©Kawasaki Motors Corp 1974 Printed in USA

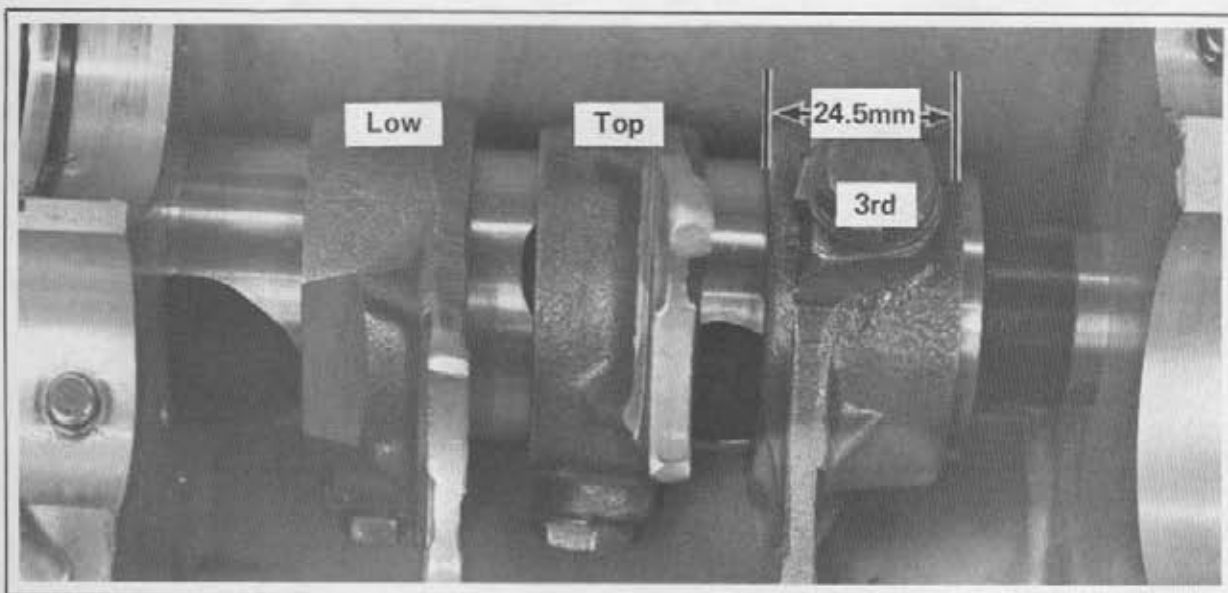
H1/H2 transmission problems have often included poor third gear engagement. This may be caused by two possible problems including the play of the fixed gears on the shafts and the lack of positive action in the third gear shift fork.

The second problem has been countermeasured by widening the base of the shift fork to keep the fork more rigid on the shift drum. This wider fork is supported on both sides of the groove on the shift drum.

The new fork is easily recognized by its wide base.

DESCRIPTION	OLD PARTS		NEW PARTS		INTER-CHANGE	EFFECTIVE I.D.
	P/N	REMARKS	P/N	REMARKS	OLD ↔ NEW	
3rd gear shift fork H1	13140-013	21.0mm wide	13140-064	24.5mm wide		KAE-87023
3rd gear shift fork H2	13140-048	21.0mm wide	13140-065	24.5mm wide		H2E-31941

### SWINGING ARM PIVOT SHAFT:

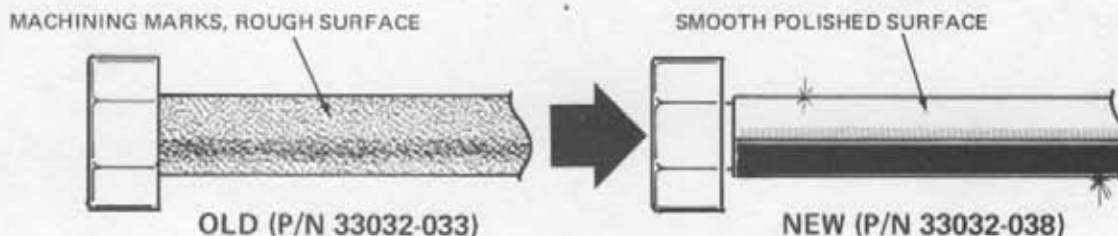
The H2A pivot shaft has a smooth polished surface as compared to the H2 pivot shaft which has a semi-rough machined surface.

### BUSHINGS:

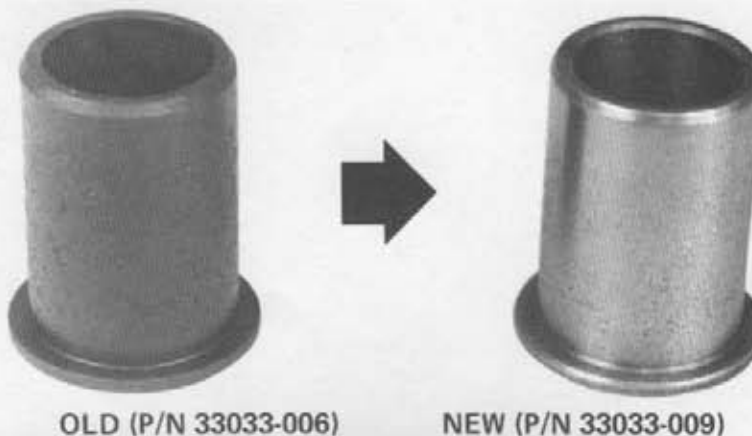
The H2 uses phenolic bushings made of a cotton or asbestos filler bonded with a phenolic resin. The H2A uses sintered iron bushings for better resistance to wear and fracture. The sintering process produces a spongelike structure in the metal making it capable of absorbing 20 percent of the total volume with lubricant. This type of bearing is ideal in areas where lubrication is infrequent.

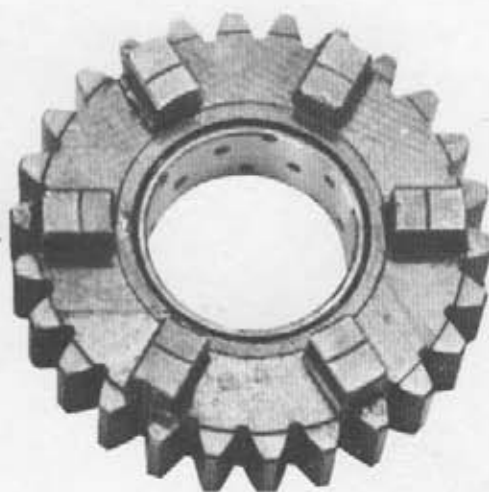
In the transmissions of H1 models there is a possibility for unusually fast wear on the inside of top gear on the drive shaft. As the gear wears, it begins to wobble on the shaft, eventually causing serious trouble in the transmission.

To eliminate this possibility, top gear on the drive shaft has been changed. The new gear is made with a pressed in bronze bushing for extended life. This change has been applied to all H1's in production from frame number KAF-57161, and to all H2's from beginning of production.

### B. CORRECTIVE ACTION FOR 5TH GEAR:

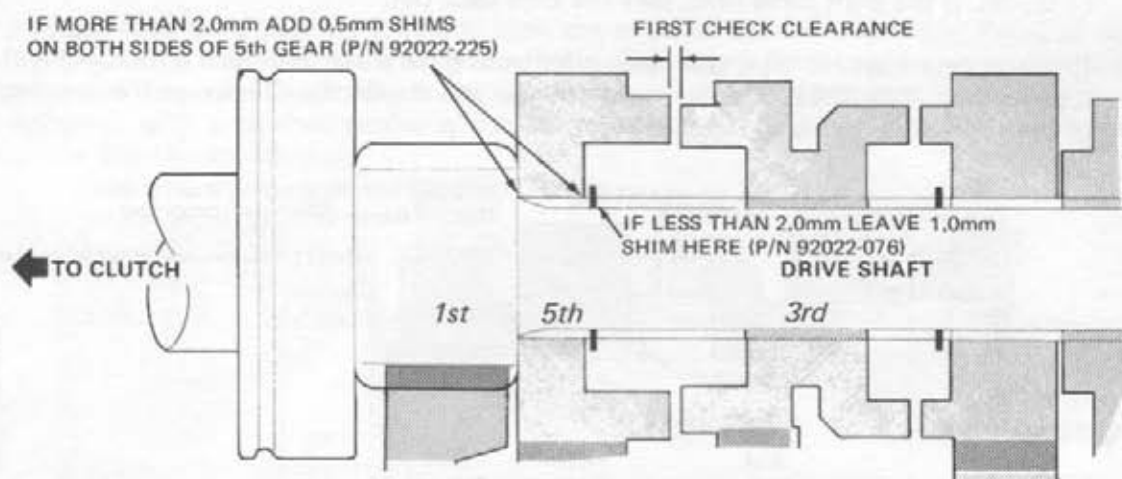
- To eliminate jumping out of fifth gear, measure the clearance between fifth and third gear dogs on the drive shaft. If the clearance is over 2.0mm, remove the factory installed 1.0mm shim (P/N 92022-076) between fifth gear and the circlip, and add a 0.5mm (92022-225) shim on either side of fifth gear. This moves fifth gear 0.5mm closer to the slider gear, assuring a more positive engagement. If the clearance is less than 2.0mm between dogs on the two gears, then leave the 1.0mm shim where it is.

Problem	Check Clearance	Take Out	Insert
Jumping out of 5th gear.	Ck clearance between 5th and 3rd gear dogs on drive shaft.	If clearance is greater than 2.0mm take out 1.0mm shim between 5th and circlip.	Insert 0.5mm shim (P/N 92022-225) on either side of 5th gear on the drive shaft.
		If less than 2.0mm leave shim where it is.

### C. CORRECTIVE ACTION FOR 1ST GEAR:

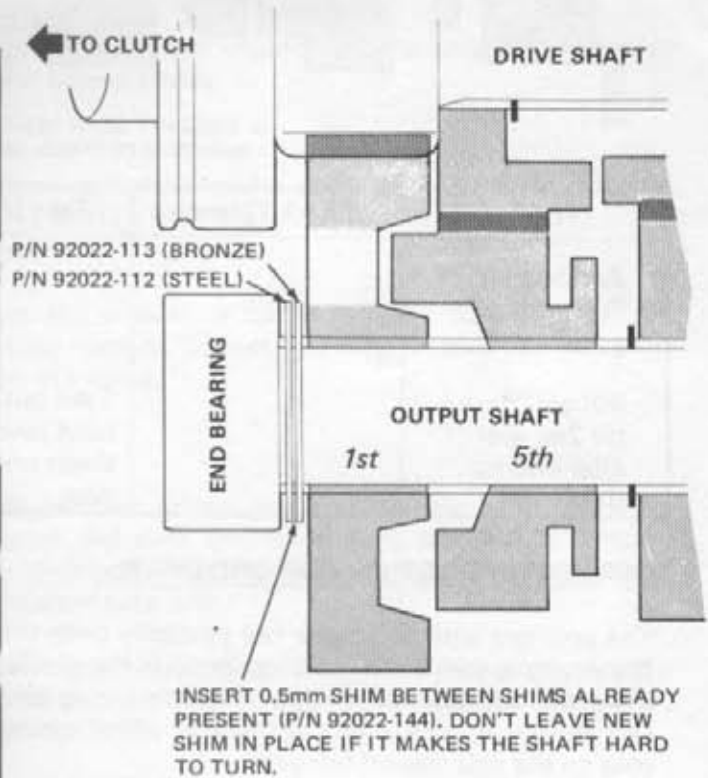
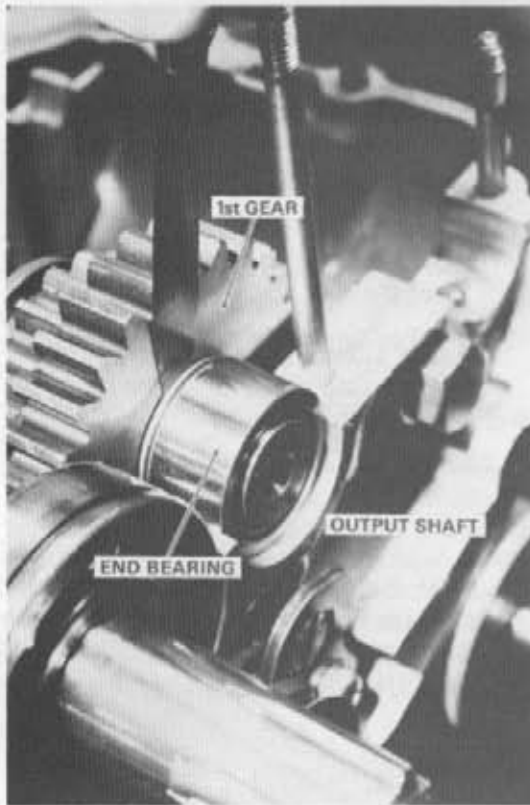
To correct poor engagement of 1st gear, insert an 0.5mm shim (P/N 92022-144) between first gear and the end bearing on the output shaft. This is in addition to the shims already present (P/N 92022-112, -113). This moves 1st gear slightly closer to the slider gear and eliminates play which may have contributed to jumping out of gear. If adding this shim makes the output shaft hard to turn, then take it back out.

Problem	Check Clearance	Take Out	Insert
Poor 1st gear engagement.			Add 0.5mm shim (P/N 92022-144) between first gear and end bearing on the output shaft.
Transmission binds after adding shim.		Take out new shims.

### D. CORRECTIVE ACTION FOR 2ND GEAR:

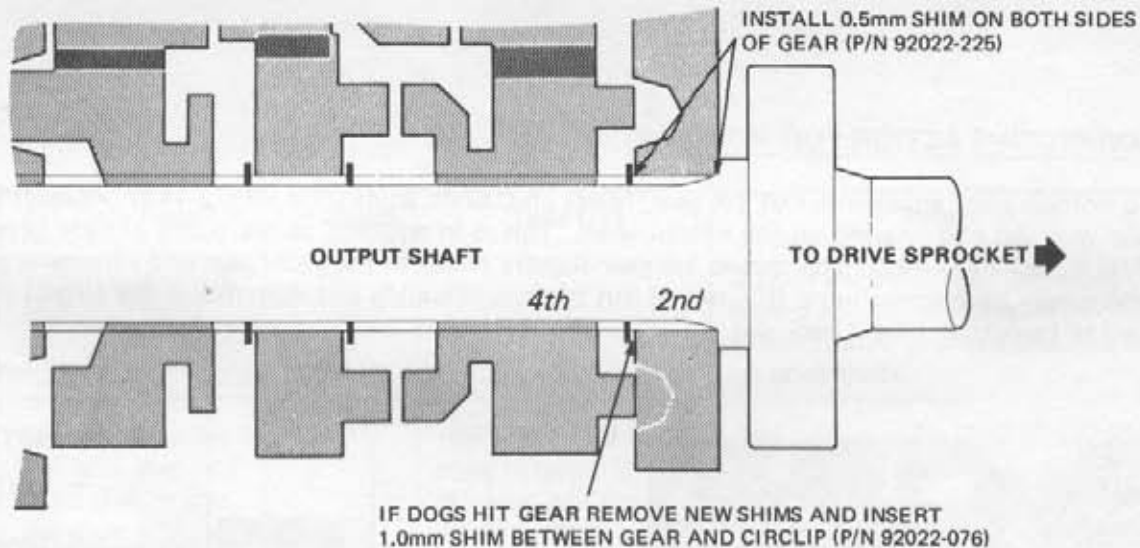
To eliminate play at second gear on the output shaft, install a 0.5mm washer (P/N 92022-225) on both sides of the gear. This moves the gear slightly closer to the fourth gear slider as well as reducing play. If the dogs on fourth gear hit second gear after the shims are added, remove both new shims and add a 1.0mm shim (92022-076) between second gear and the circlip. This will keep the dogs from hitting, while eliminating play at second gear.

Problem	Check Clearance	Take Out	Insert
Jumping out of 2nd gear.			Add 0.5mm shim (92022-225) on both sides of 2nd gear on the output shaft.
4th gear dogs hit 2nd gear after adding shims.		Take out both new shims on 2nd gear.	Add 1.0mm shim (92022-076) between 2nd gear and circlip on output shaft.

#### E. CORRECTIVE ACTION FOR 3RD GEAR:

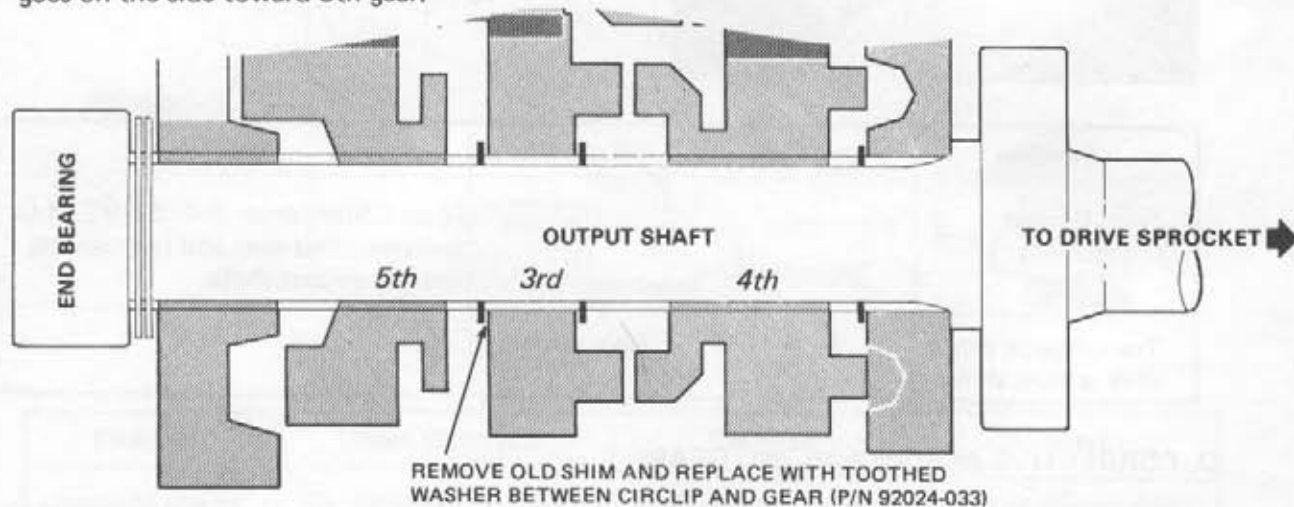
The problem with third gear has primarily been the result of the shim between 3rd gear and the circlip spinning and wearing through the circlip. This causes third gear to move away from the slider and hop out of gear. The solution is to remove the standard shim (P/N 92022-076) and replace it with a toothed washer which cannot rotate (P/N 92024-033). The new washer goes on the side toward 5th gear.

Problem	Check Clearance	Take Out	Insert
Jumps out of 3rd gear.		Remove 1.0mm shim between 3rd gear and circlip on output shaft.	Insert 1.0mm toothed thrust washer (P/N 92024-033) between 3rd gear and circlip (5th gear side).

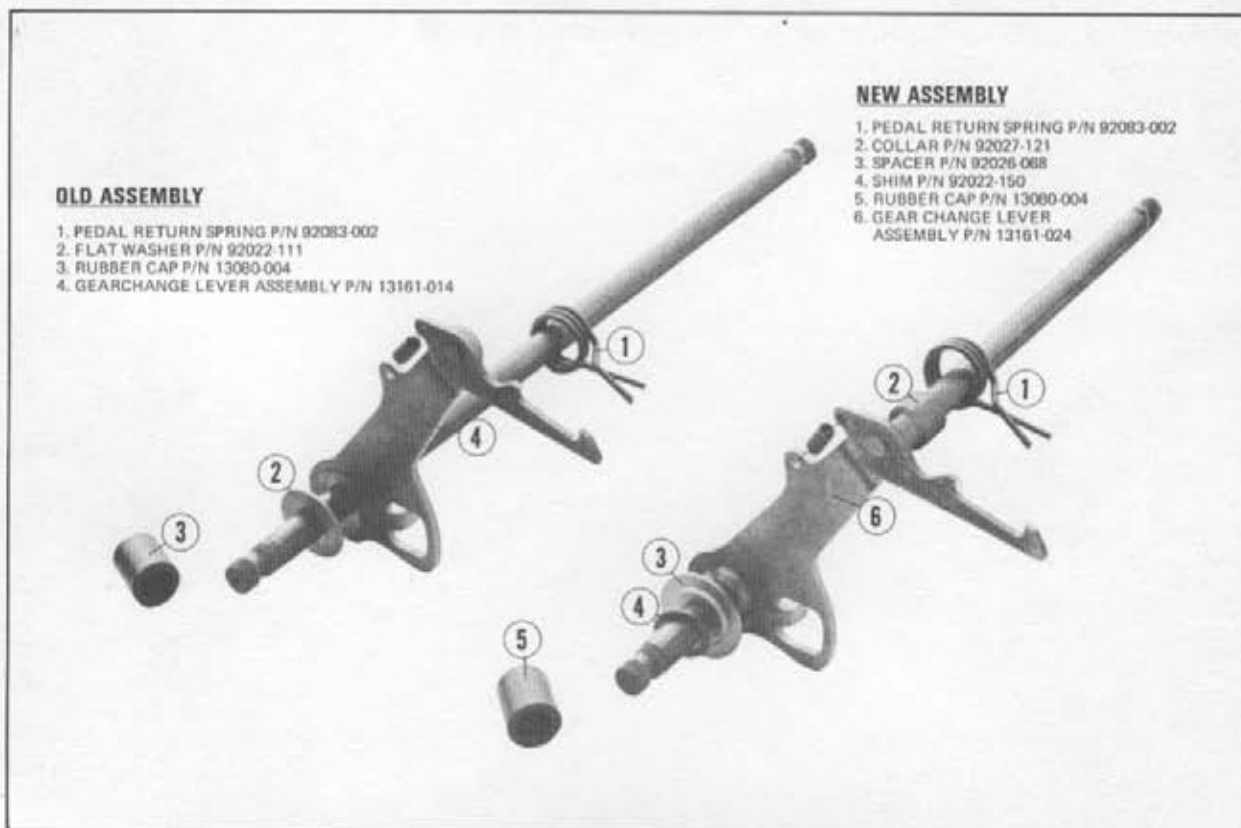
On the early H1 models, the gear change lever assembly consisted of a toothed lever staked to a rod. This construction sometimes loosened up, causing sloppiness in shift lever movement. This contributed to missed shifts, and sometimes led to transmission damage.

An additional point of confusion comes from a variation in the assembly as pictured in the parts manuals for H1B and H1D.

To remedy this problem, a new gear change lever assembly was designed for the H1 and H2. The new unit is welded, rather than staked, and includes a collar inside the pedal return spring, a spacer, and a shim outside the spacer.

The correct assembly of the new gear change lever assembly is pictured on the right below. The outside shim (P/N 92022-150) does not yet appear in any parts books but it is included in the position shown on current production machines of both H1 and H2. The new assembly is used on all H1's after Engine No. KAE 43902 and on all H2's, and is interchangeable with older parts.

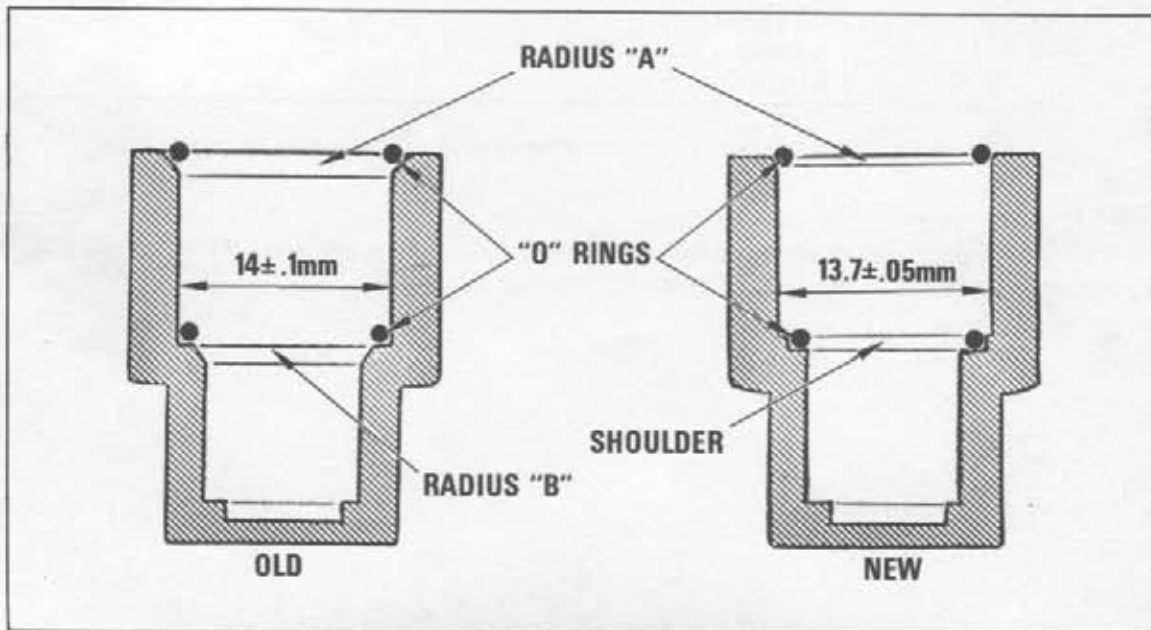
This problem has been traced to faulty O-ring seating in the oil pump end cover. After installation, the two O-rings inside the cover shrink approximately .1 to .2mm in diameter. This shrinkage allows oil to seep around the seals and into the end cover chamber. From this point, the excess oil is pumped to the right cylinder which is serviced by the end cover orifice, resulting in smoking and premature sparkplug failure.

- Radius "A" has been decreased in depth to give the O-rings less "squish" space, making a tighter seal.
- Radius "B" has been eliminated altogether, improving the seal at this point.
- The internal diameter of the chamber has been decreased from  $14 \pm .1\text{mm}$  to  $13.7 \pm .05\text{mm}$  to compensate for O-ring shrinkage.
- A slight shoulder has been added to the base of the new chamber to further compress the O-ring.

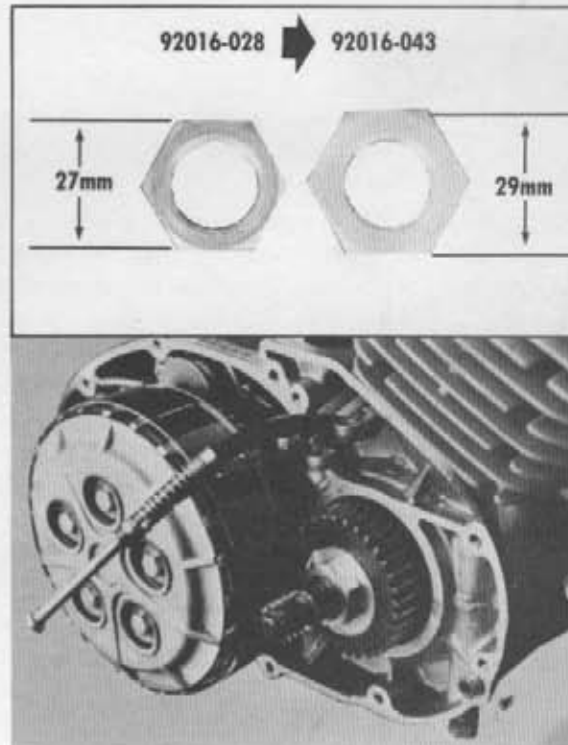
Surprisingly, the primary pinion nut does not loosen (turn) on the crankshaft. Instead, the lockwasher is crushed, relieving the pinion of nut tension. Then the gear is held from twisting only by the woodruff key. As the drawing below shows, the "crush" area on the lockwasher, which is determined by the I.D. of the pinion gear and the O.D. of the pinion nut, is very small.

A new larger nut, with a 29mm O.D., is used to increase the lockwasher crush area and eliminate washer extrusion. The larger nut has been installed in all H2's after engine number H2E-05228.

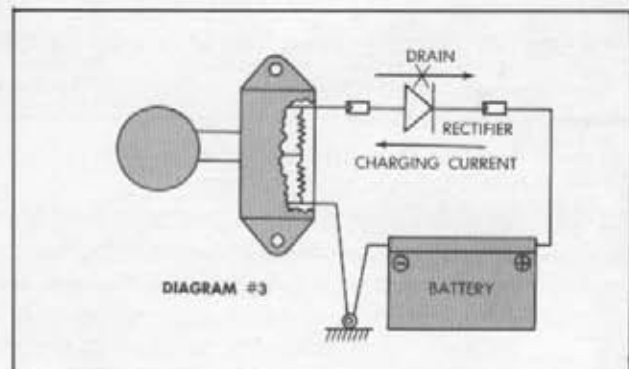
A supplemental rectifier has been developed to stop reverse current leakage, and yet allow generator current to charge the battery.

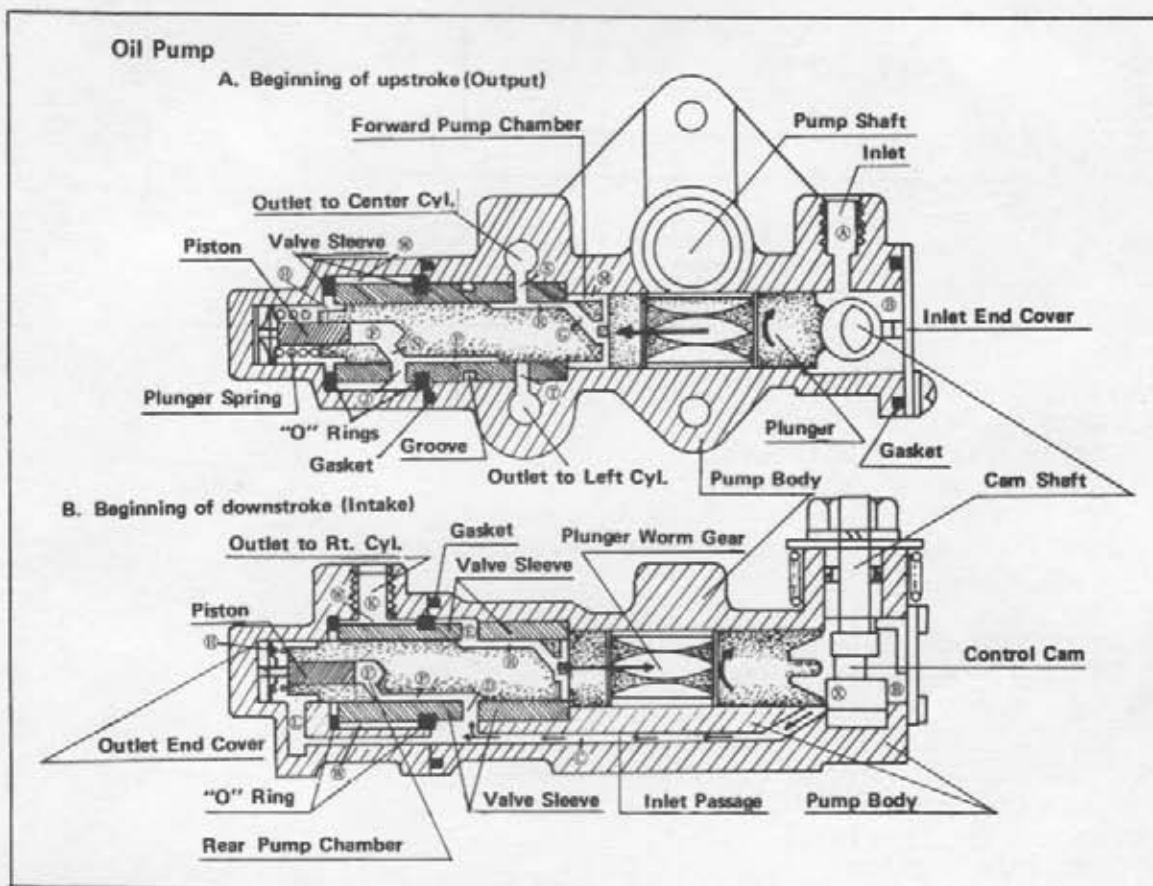
- A. Page 20, Paragraph e.  
The connecting rod small end play service limit should be 0.0039 in. (0.10mm).
- B. Page 28, Second Column. Line five should read:  
"the clutch hub. Thus, the drive train is as"
- C. Page 44. Diagram 182 should be corrected to match the following diagram:

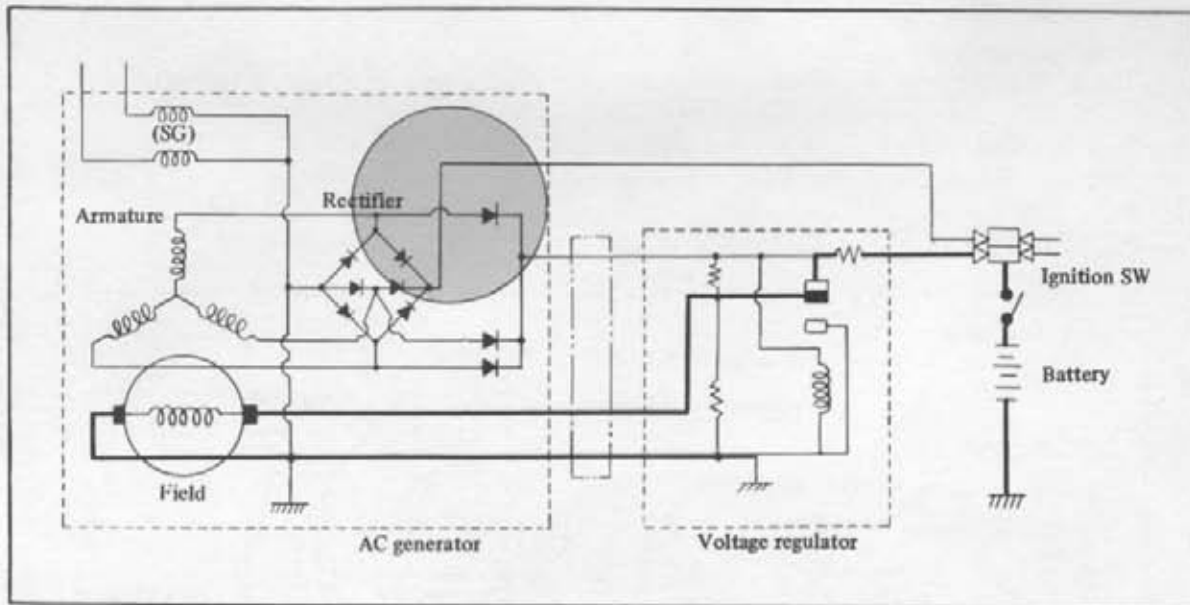
- I. Page 65, Table 31 Spring Length:  
 H2 Standard Rear Length should read "2.36 in. (60mm)"  
 H2 Service Limit Rear Length should read "2.48 in. (63mm)"
- J. Page 104, Diagram #399 should be corrected to match the diagram below:
